ST12 Steam Enhanced Extraction: Has criteria for termination of Steam Injection Been Met?

Status as of 11/6/15 Weekly Progress Report

Progress Report
Steam Enhanced Extraction Remediation at the Former Williams AFB (E8002) Site, Phase 42
November 5, 2015

Figure 29. NAPL Screening Results and Calculated Benzene Concentrations - Lower Saturated Zone

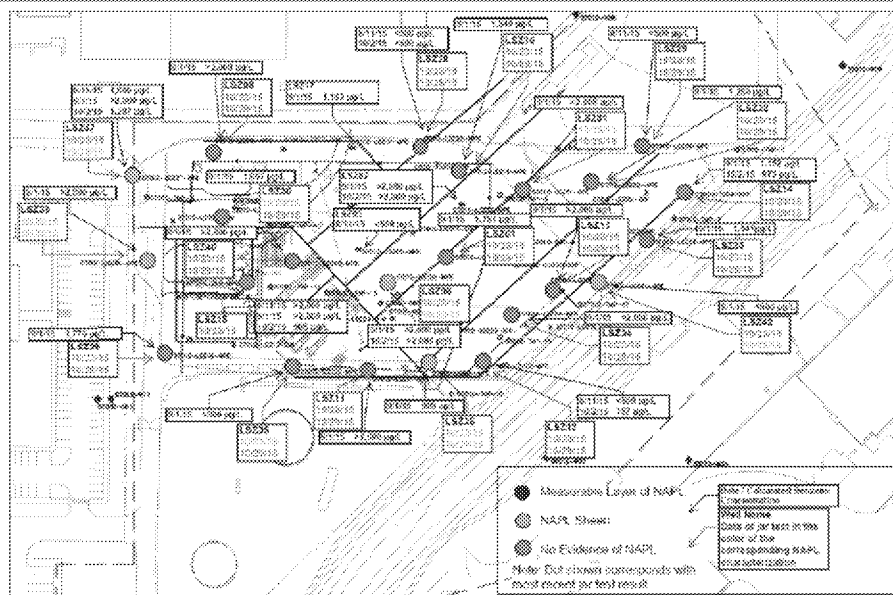
Benzene Concentrations in LSZ Exceed 500 µg/L; Criteria has not been met for LSZ

Figure 26. NAPL Screening Results and Calculated Benzene Concentrations – Upper Water Bearing Zone

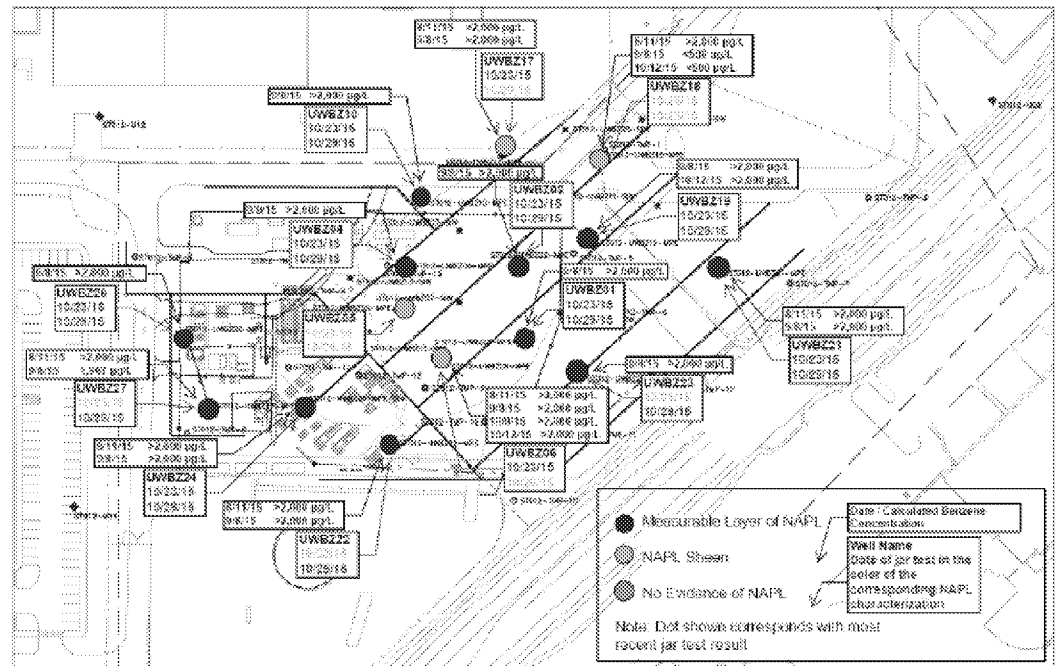
Benzene Concentrations in UWBZ exceed 500 $\mu\text{g/L}$; significant NAPL present, Criteria has not been met for UWBZ

Figure 27. NAPL Screening Results and Calculated Benzene Concentrations – Cobble Zone

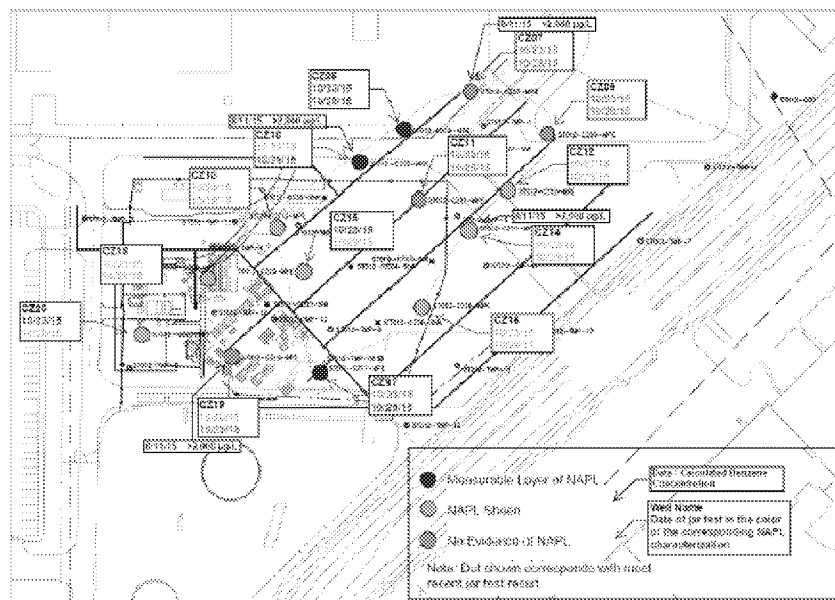
Benzene concentrations Exceed 500 $\mu\text{g/L}$ in CZ, NAPL present; Criteria has not been met for CZ

Figure 4. Daily Mass Removed

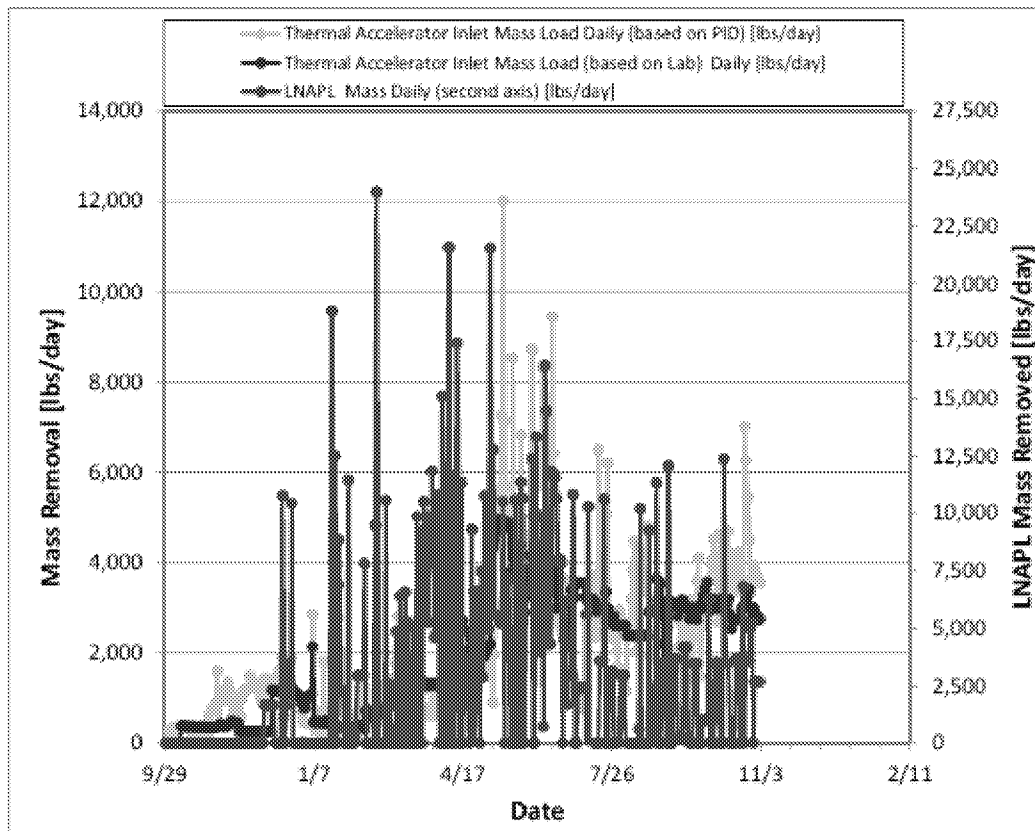
LNAPL recovery is 30% of peak removal rate; vapor recovery is 50% of peak removal rate; Criteria for termination of steam injection has not been met

Figure 5. Average Soil Temperatures

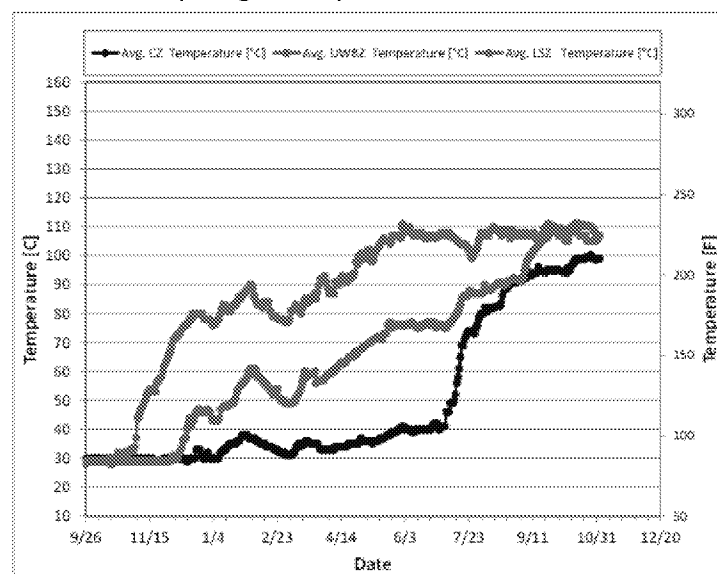
Criteria for Boiling Temperatures has just barely been met.
